# **Attachment A4**

**Urban Design Report – Bates Smart – 15-25  
Hunter and 105-107 Pitt Street, Sydney -  
Part 3**

15-23 Hunter Street and  
105-107 Pitt Street Sydney

# Design Advisory Panel Feedback

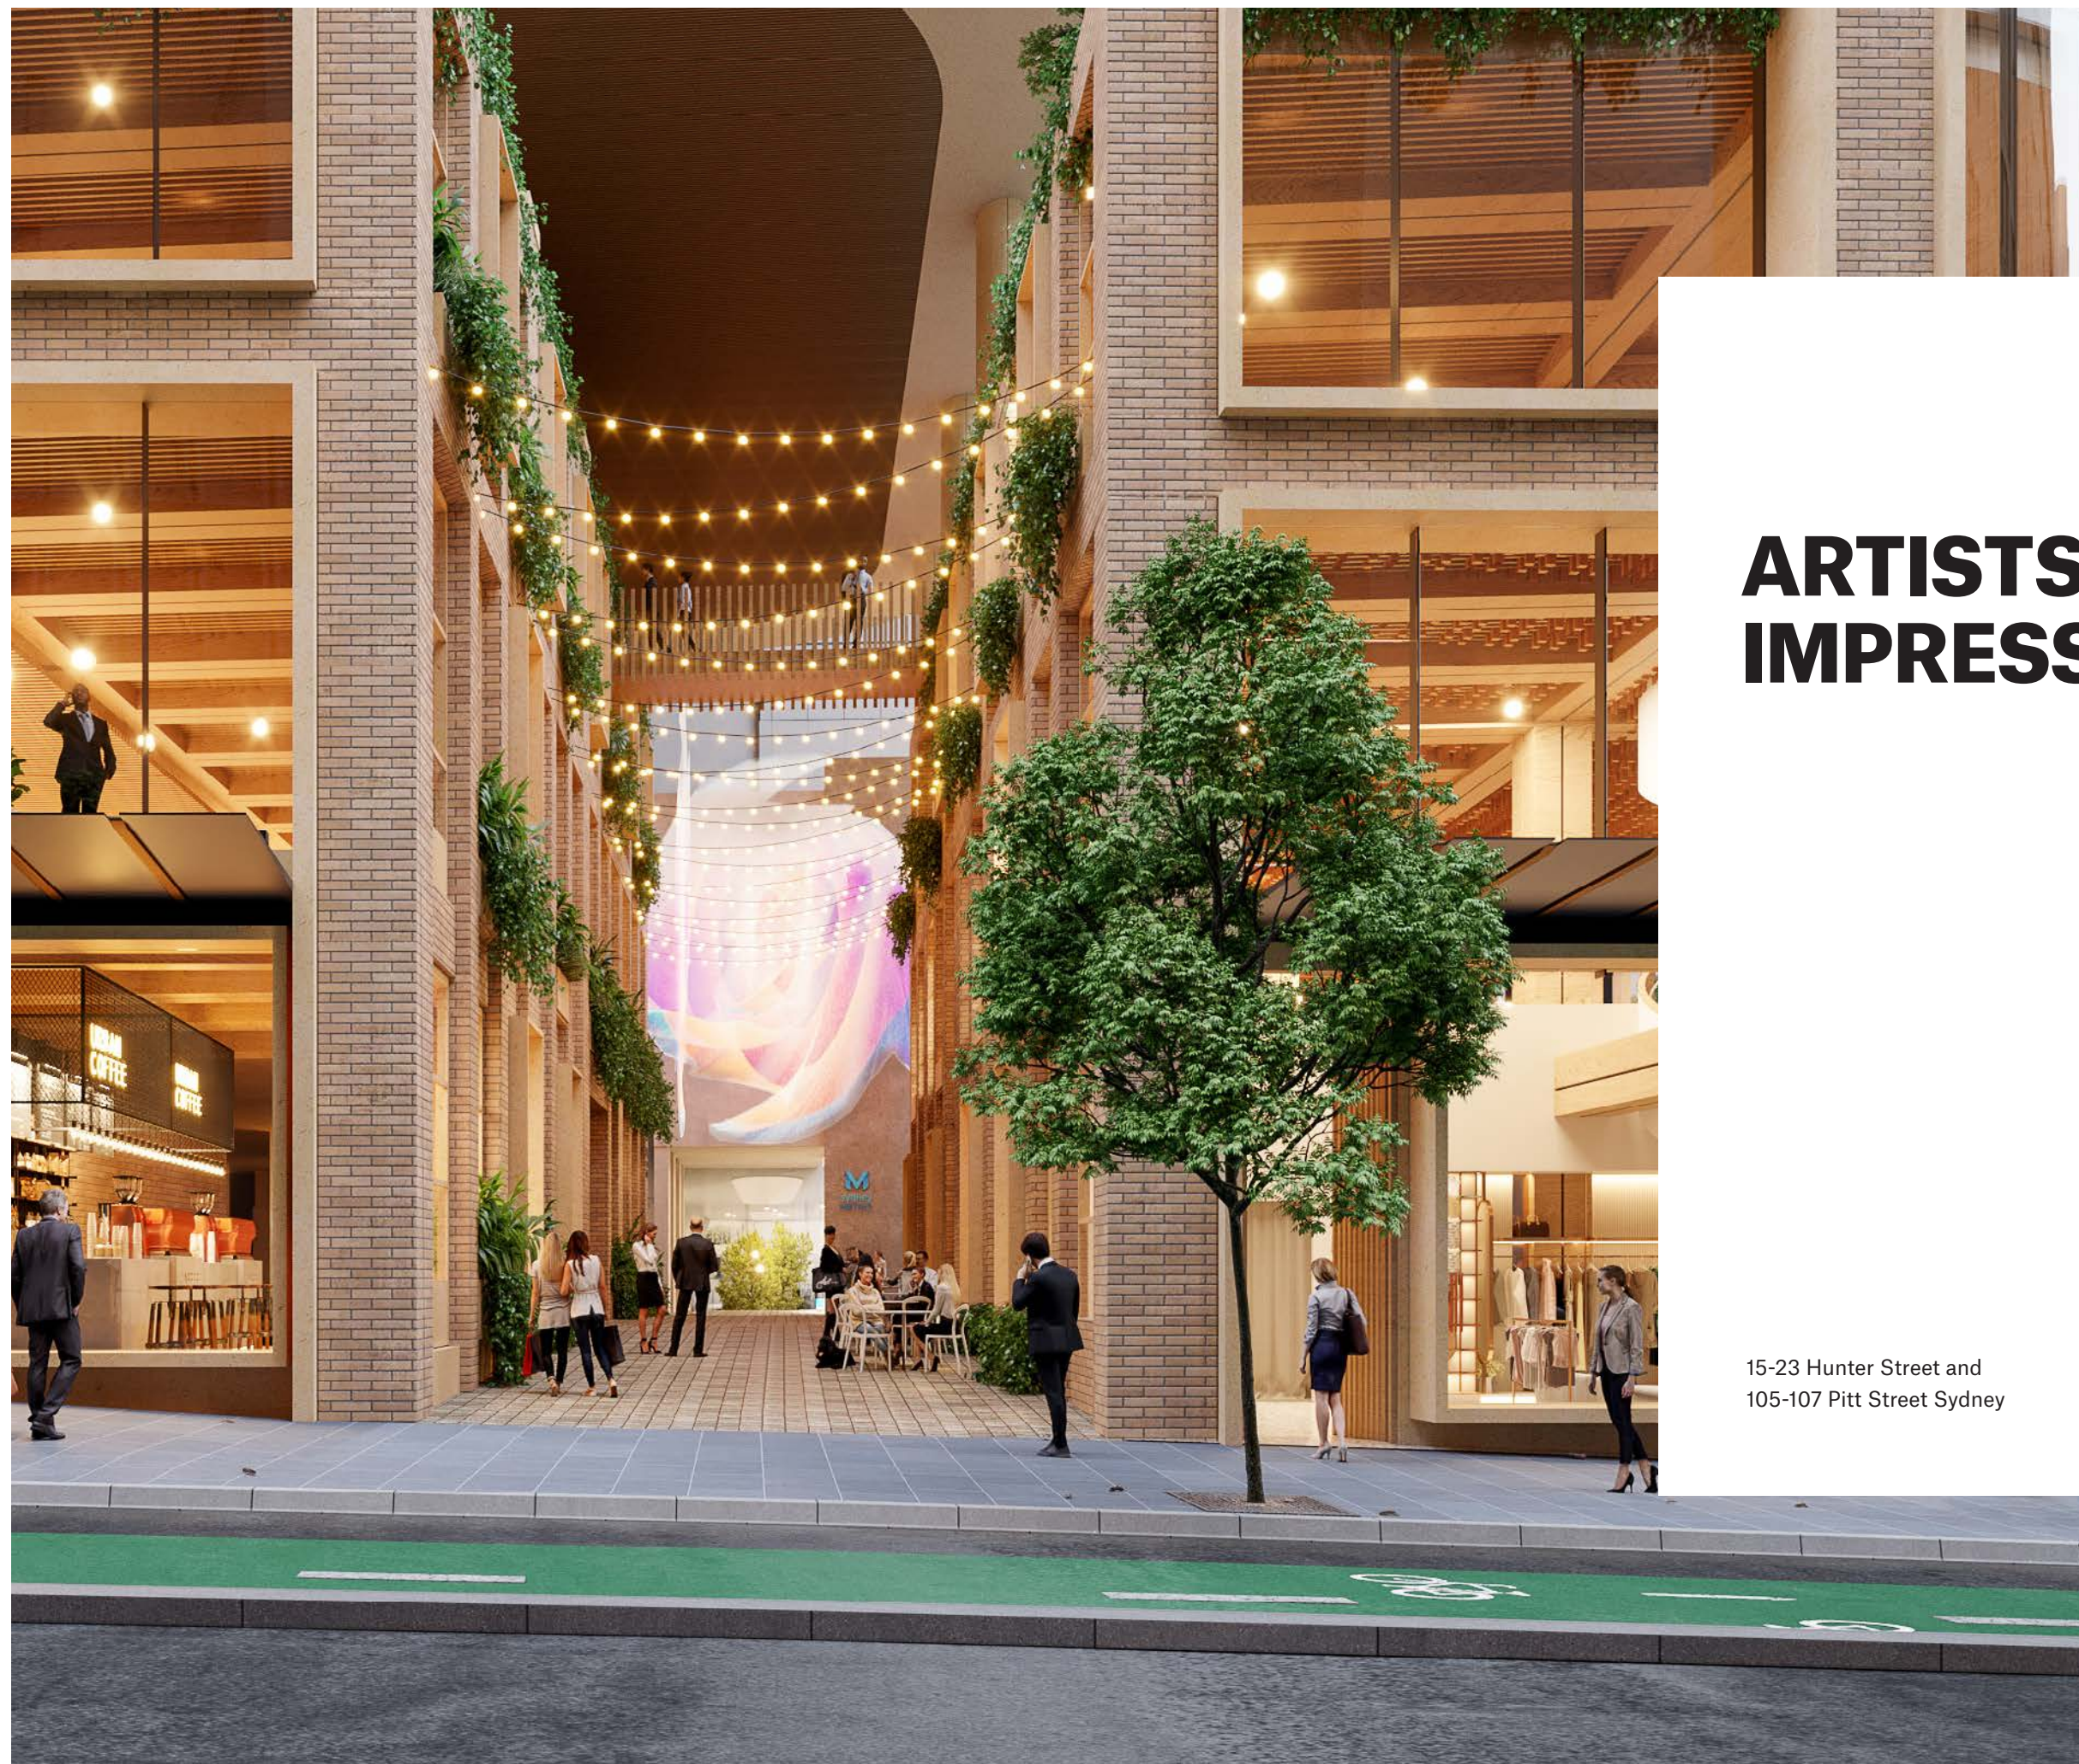
PEDESTRIAN PRIORITY IN THE LANEWAYS
DAP was concerned that the creation of a pedestrian priority laneway with outdoor dining is not compatible with the constraints of vehicle access and servicing requirements, and compounded by issues of flooding and universal access. It is noted that the revised reference scheme ground floor plan provided on 10 December 2021 removes the pedestrian and vehicle shared laneway arrangement.
Retail activation would be required within the lanes to ensure these spaces are attractive and do not appear as a ‘back of house’ area. This should be detailed on updated reference plans.

PARKING AND SERVICE VEHICLE SPACE
The revised ground floor plan increases the service vehicle spaces from 4 to 6 (potentially 7) spaces, however this is still considered to be too low, noting the DCP requires 17 spaces. This suggests the proposal is trying fit on the ground floor what would normally be provided below ground.
DAP recommended a review of the cycle access and amenity proposed. Potential conflicts between vehicles, pedestrians and cyclists need to be minimised, and any lifts to the end of trip facilities need to be of an appropriate size to accommodate bikes. The location of the end of trip facilities, and how these will be accessed, are not clear on the updated ground floor plan and this information will need to be provided in revised documentation.

BASEMENT DESIGN
DAP was concerned about the proposed five levels of underground retail/gym, and how the underground levels interface with the Tank Stream tunnels. DAP questioned the viability of the underground retail if they are not connected to the Metro station and associated underground access. It was also noted that the five levels of underground retail exacerbate the loading and servicing issues.
Updated plans would need to be provided to detail any changes to this proposed arrangement. Any through-site pedestrian links to the future Metro to the west will need careful coordination regarding access widths and levels. This is not yet evident.
It is also recommended that if there are discussions with Metro regarding potential connections with this site, these should be provided to us so we understand this and can incorporate these into our considerations of controls for the site.

HERITAGE
DAP supported the heritage listing of 15-17 Hunter Street, although further investigation is needed on the interface between new and old at ground floor, and heritage objects in the building. There is also a need to acknowledge the Tank Stream in the public domain.
Details should be provided for the treatments of the ground and upper floors of the rear of this building, including the hoists , which should be visible due to their heritage significance. It is also unclear how this building would relate to the flood planning levels in the laneway.

ARTICULATION ALLOWANCE
DAP recommended that refinement of the building envelope should provide the previously recommended 15% articulation provision.

ADDRESSED	✓
Laneway is completely pedestrianized. All vehicular traffic is via Pitt Street. Due to flooding requirements, it is not possible to use a conventional ramp to go up, crest, and go down fast enough to go under the laneway. As such, vehicular lifts are used.

ADDRESSED	✓
16 spaces for service vehicles / couriers are provided. This is comprised of: five spaces at L00 (including two MRV bays), four spaces at B01, & seven spaces at B02.	
Traffic engineers at WSP have reviewed the proposed design and believes the revised layouts will provide a succesful level of amenity & service.

ADDRESSED	✓
A clear ground level link is provided to Metro Hunter Street.	
A direct B01 connection to Metro's Bligh Street entrance is envisaged.	
Only 2 levels are considered to be F&B.	
B03 & B04 are Gym / Spa, with EOT at B05.

ADDRESSED	✓
<p>The rear of 15-17 Hunter Street is predominantly retained in the current proposal. Specifically the upper levels will be retained in their current configuration. The lower two levels of the rear will include strategic openings to allow pedestrian flow to the metro concourse. The hoists and arches will be retained, and reference to the original function of the rear as a warehouse style loading area will be provided.</p>

ADDRESSED	✓
The requested articulation level has been adopted.
